Proposed Revisions to a Standard Plans Index

Index Number: 515-022

Index Title: Pedestrian/Bicycle Bullet Railing Details

FY 2022-23
STANDARD PLANS

VIEW G-G TRANSITION BASE PLATE
(Bullet Rail not shown for Clarity)

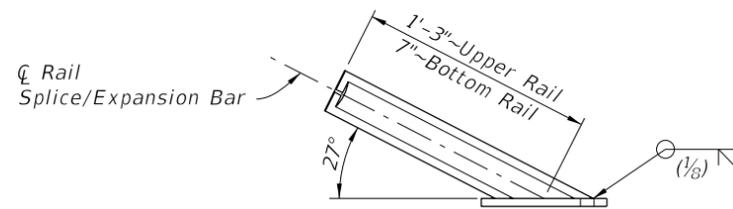
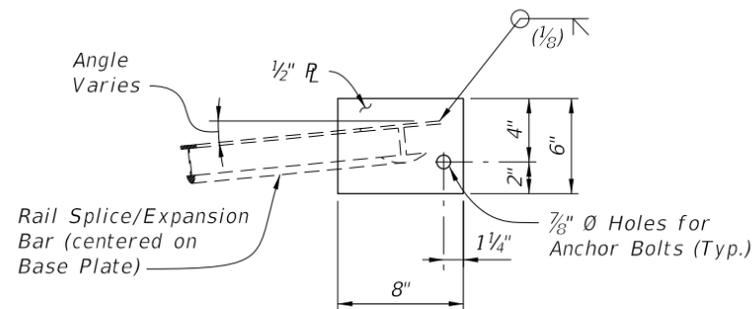
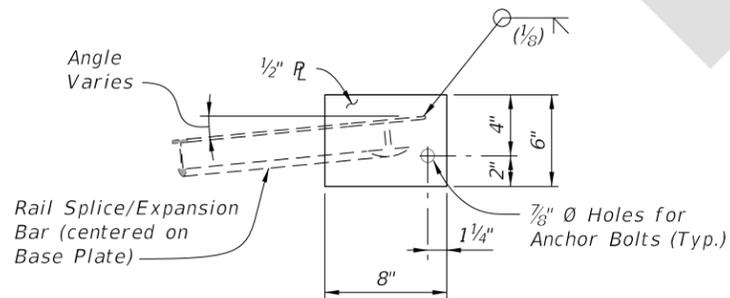
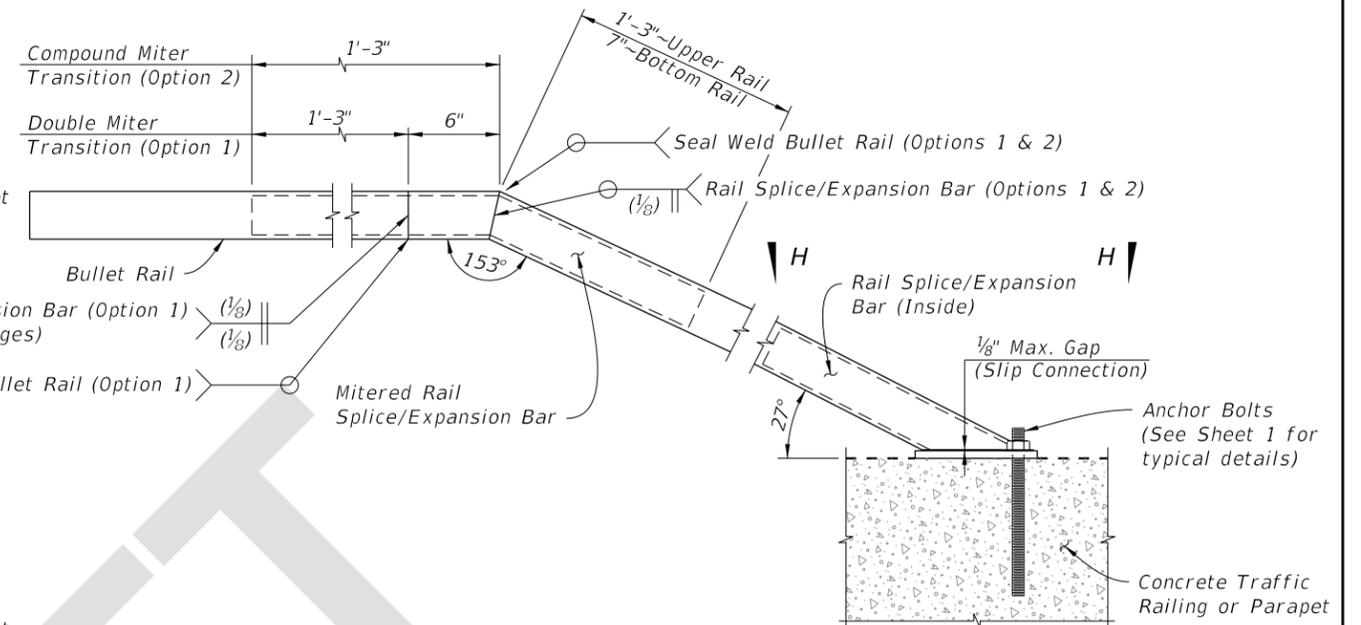
Sheet 3: Corrected the relative location and dimensions of the base plate and post with respect to the edge of the bullet rail.

Dimensions and drafting associated with the rail were corrected to reflect its correct orientation. The rail had been drafted as if it were facing down in plan which was incorrect.

Edited details to correct the orientation of the rail.
